TOWN OF CARLISLE, MASSACHUSETTS  
ZONING BOARD OF APPEALS  
DECISION UPON APPLICATION OF LIFETIME GREEN HOMES, LLC  
FOR A COMPREHENSIVE PERMIT UNDER  
MASSACHUSETTS GENERAL LAWS CHAPTER 40B

APPLICANT: Lifetime Green Homes, LLC (the "Applicant")

PROPERTY: 100 Long Ridge Road, Carlisle, MA

PROPOSAL: Twenty (20) for-sale, single-family detached residential condominium units, of which nineteen (19) are new construction and one (1) is an existing house, to be served by eleven (11) private drinking water wells and an on-site septic system made up of four separate component systems (three new systems plus the existing system that serves the existing house), to be located on a 9.84 acre parcel.

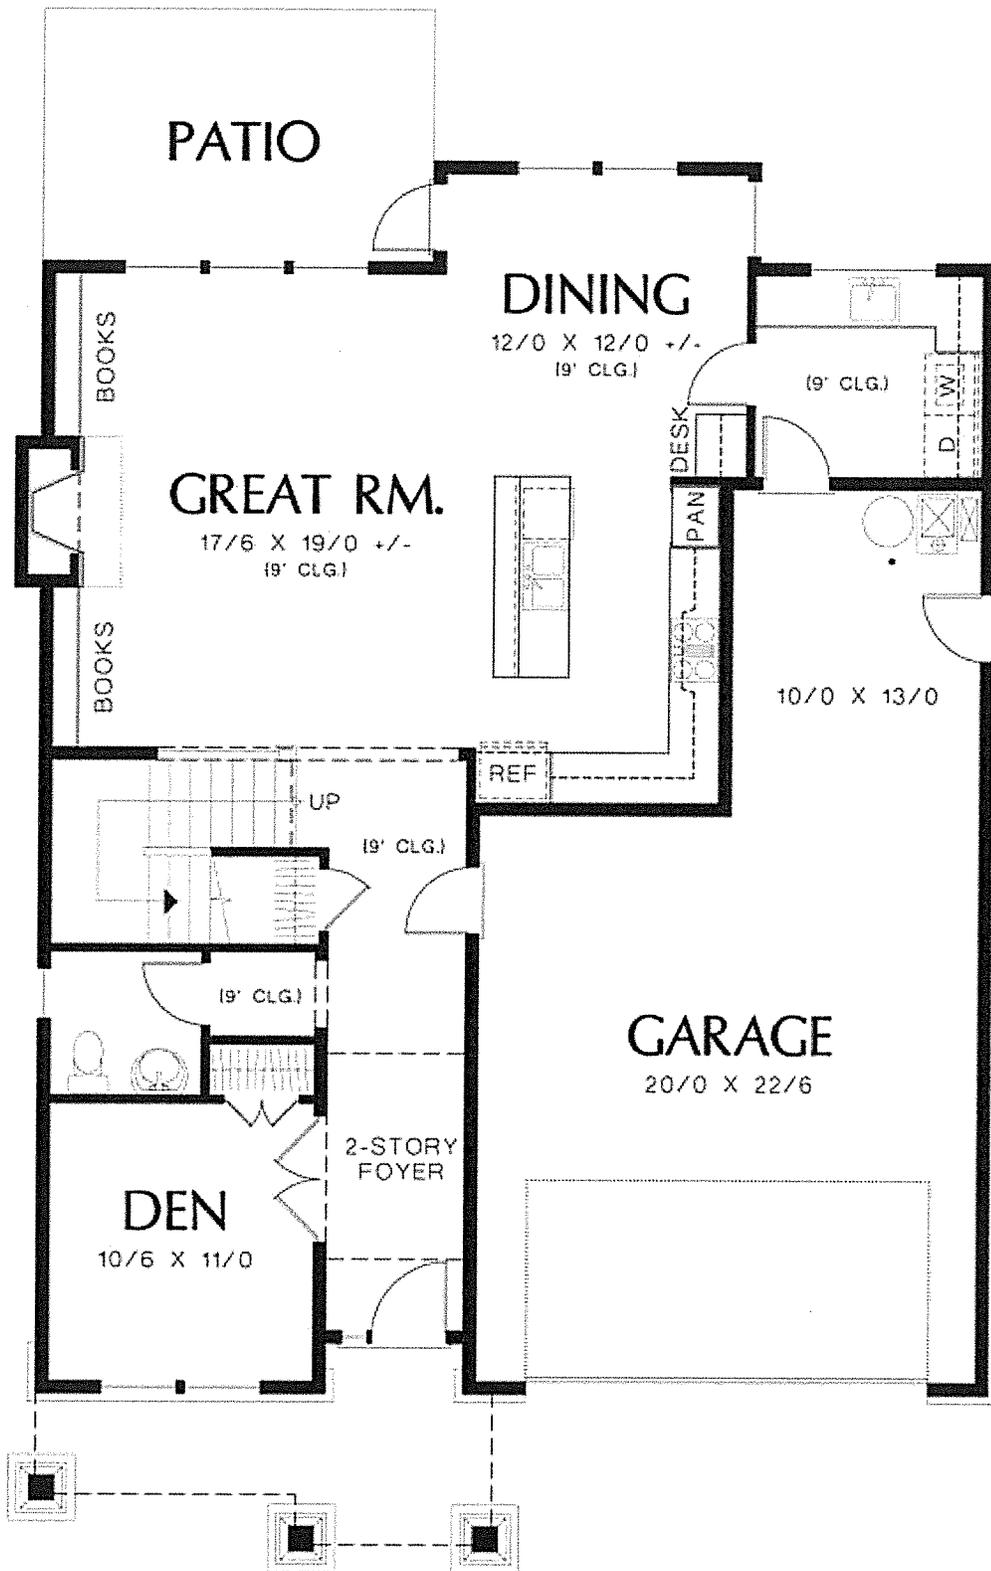
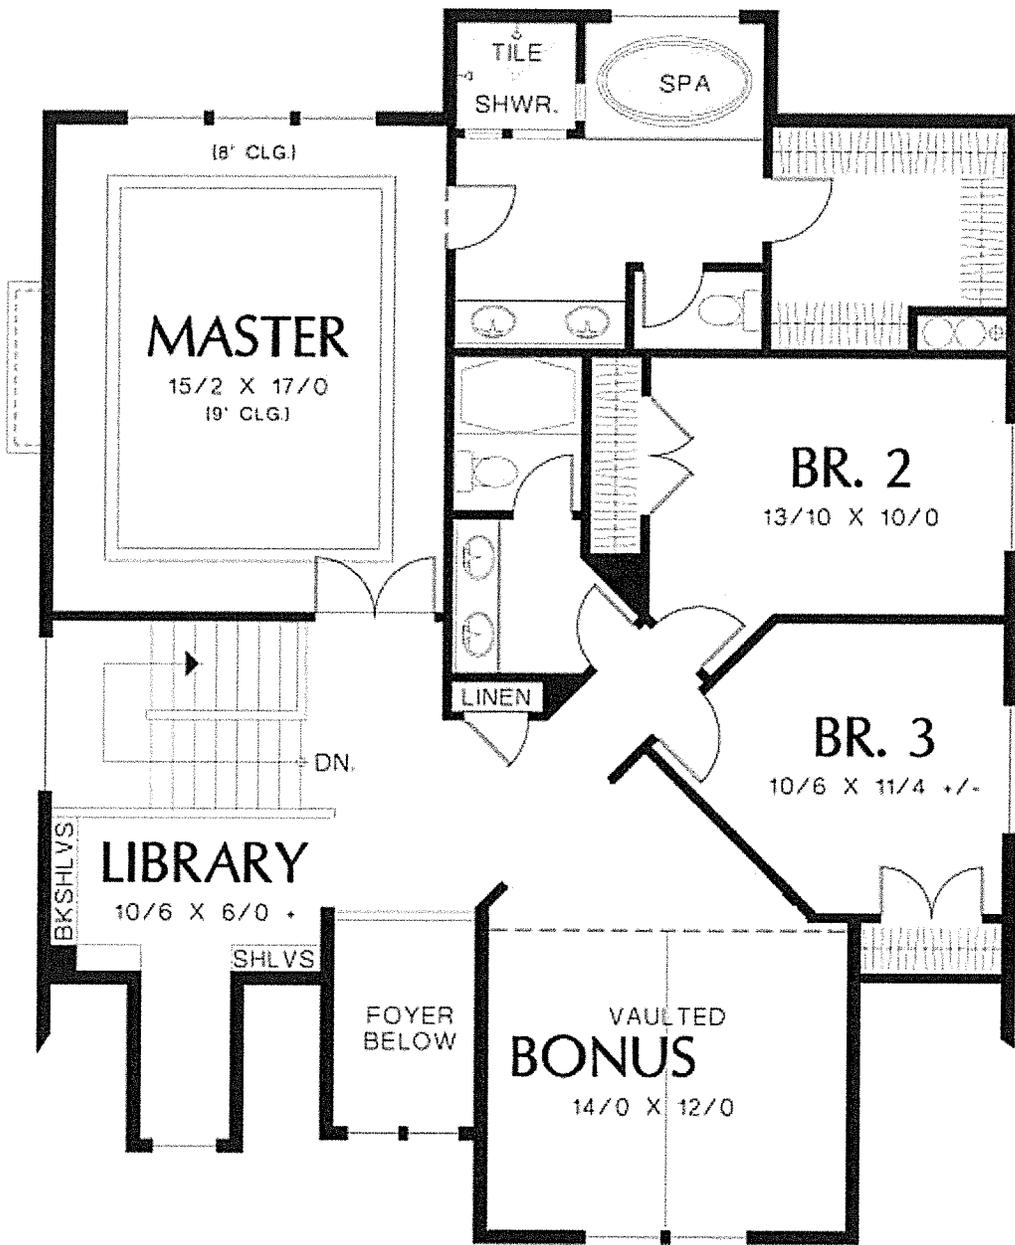
Adjustments to include:

- a. Roof Line – Eliminate Hip
- b. Change Gable Trim with less cantilever and column widths to match other houses
- c. Consistency with Trim Band over 2<sup>nd</sup> floor windows
- d. Double window to replace triple in MB
- e. Consistency with stone use between all homes
- f. Extend front porch width, if possible
- g. Consistency with roof pitch between units
